Memorandum for: Bayou City Waterkeeper on behalf of the Healthy Ports Community Coalition and the Environmental Integrity Project (EIP) in support of ongoing public advocacy efforts regarding the Houston Ship Channel Expansion Channel Improvement Project located in Harris, Chambers, and Galveston Counties, Texas. Revised from September 2025 version.

**This document was prepared by Empson Consulting, LLC,
William B. Empson, PE, PMP Principal**

Figure 2: Upland Placement Areas Map (New areas shown in red)

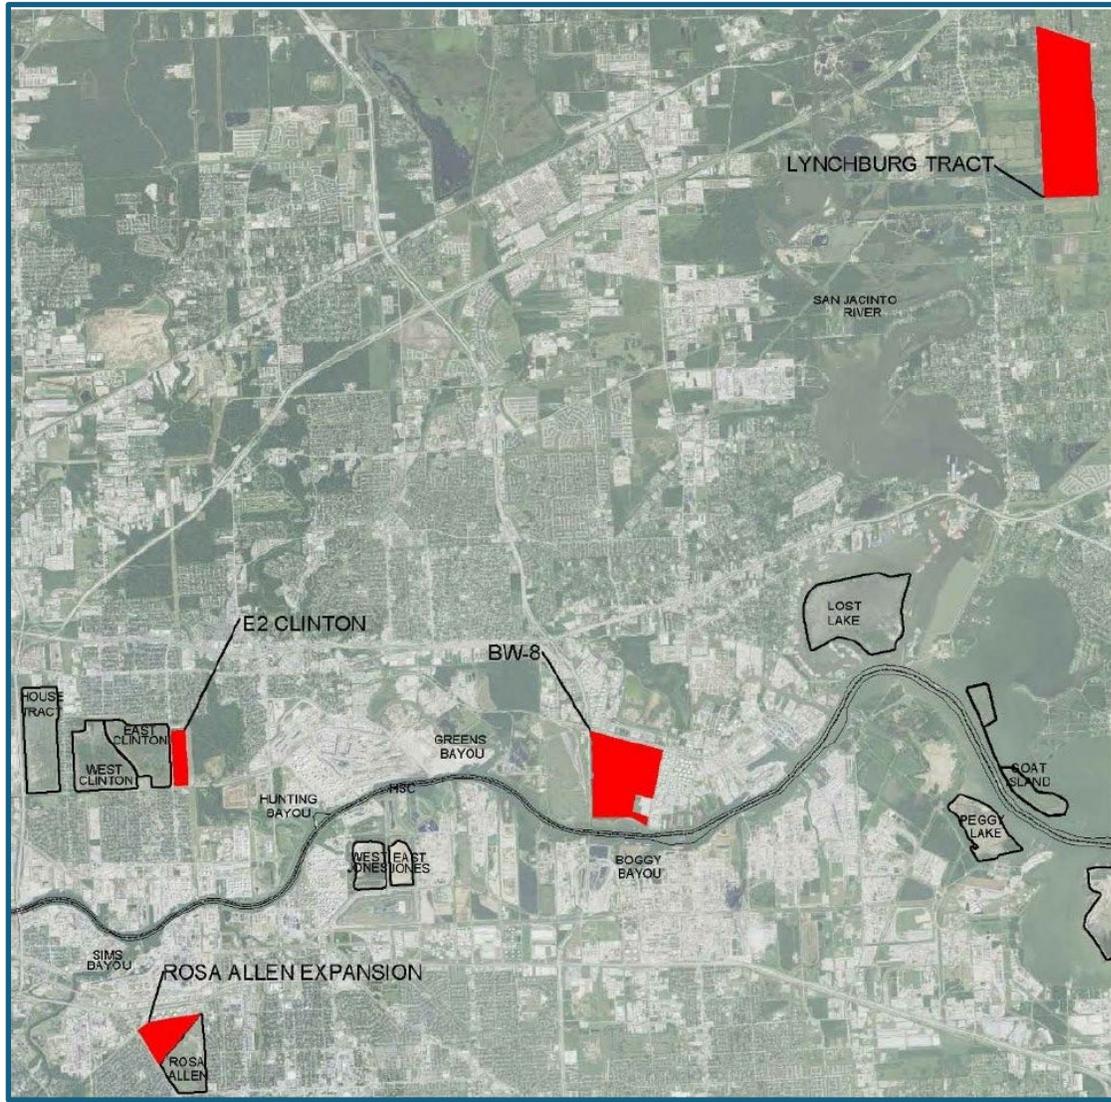
As presented in the EIS, Appendix C, three **NEW** upland confined placement areas will be constructed and used for dredged material placement:

It is unclear why the E2 Clinton and Rosa Allen sites that present significant public risk are required to be used at all given the proximity and size of the new BW-8 site and the potential to improve the dike foundation and raise the dikes on that site using modern risk informed design principals, as required by USACE guidance, all while limiting the induced risk on surrounding properties since there are no residential properties around the BW-8 site.

Figure 10: Upstream Dike Raising Method from EM 1110-2-5025.

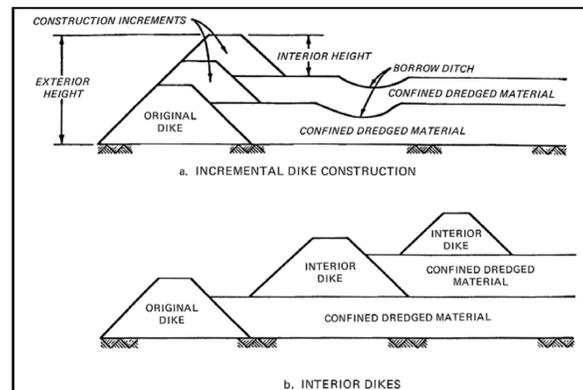
Raising of the existing placement area dikes and future raising of the dikes at the Rosa Allen placement area was and is to be accomplished by excavating material from inside of the existing placement area for mechanical handling and compaction of this previously dredged material as fill to raise the dike. This construction technique is referred to as “Upstream Raise” construction in the tailings dam industry and has been legally prohibited in Brazil due to the frequent failures and loss of life associated with this construction technique. This construction approach is particularly challenging since it relies on the dredged material inside the placement area to serve as the foundation of the dike raise and the properties of this material are largely unknown and cannot be controlled. This construction approach also exposes the dredged material in the placement area that has been moved to the berm to uncontrolled runoff and offsite migration of the dredged material that may be contaminated or may have been comingled with contaminated material in the placement area.

Figure 12: 2025 Slope Failure at East Clinton Placement Area and the 2016 Slope Stability Analysis of the same PA

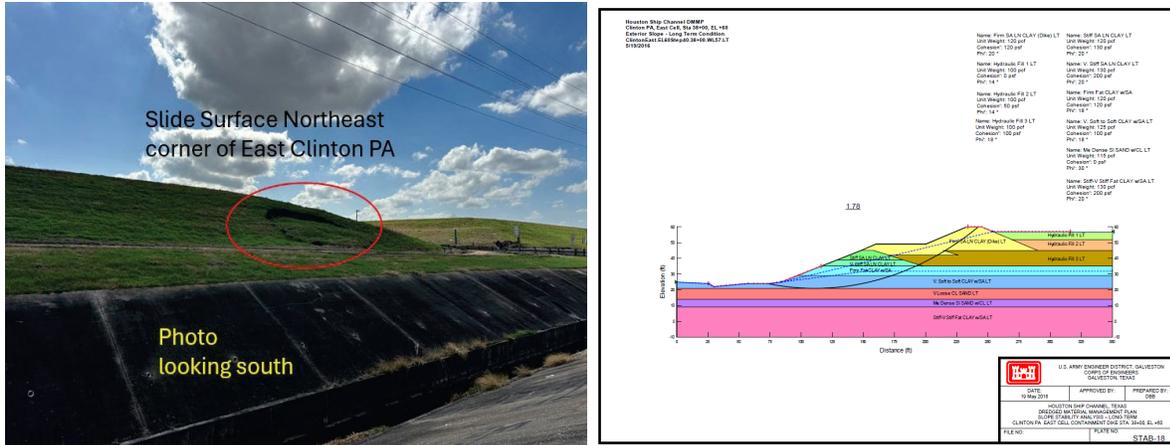
2025: In late January 2025, a slope stability failure developed at the northwest corner of the East Clinton Placement Area. This slide is documented in a 07 February 2025 CESWG-ECE-S Memorandum for Record. The slide is documented as a surface slide on the exterior of the dike and the photos included in the Memorandum appear to confirm this conclusion. The cause of the slope failure was attributed to saturation of the slope due to snow the week before. While this slope failure was not an immediate threat to the overall integrity of the placement area berm it could have progressed to a breach in the placement area had it not been reported by the public and repaired quickly. It is not clear whether the placement

The 2016 slope stability analysis for the long term stability condition on the Clinton East PA from Appendix C of the EIS is presented below and raises several concerns. The factor of safety for the critical failure surface is shown as 1.78 and is a much different slope failure than the one that actually occurred. For a slope failure that actually occurred, the analyses should show a failure surface that looks almost exactly like the one observed in the field and the factor of safety should be at or below one. The slope geometry of the dike shown in the picture from the memo is also much different, and more critical, than that shown in the slope stability analyses. The memo also notes several other undulations along the slope without defining the reason for the mention of these undulations. It is believed that the geotechnical engineer was pointing out that there may be other areas of slope movement and/or failure that have not fully developed yet. The repair of the slope failure does not appear to have investigated or addressed these other areas of concern.

Although this recent slope failure is an issue of concern it does provide an opportunity for USACE to perform a backward analysis of the failure that will allow them to calibrated the soil parameters of the dike to the actual observed performance potentially making all of their slope stability analyses more accurate. The discrepancy between the 2016 analyses and the 2025 actual behavior clearly identifies the need for updated slope stability analyses for all placement areas whether active or not.
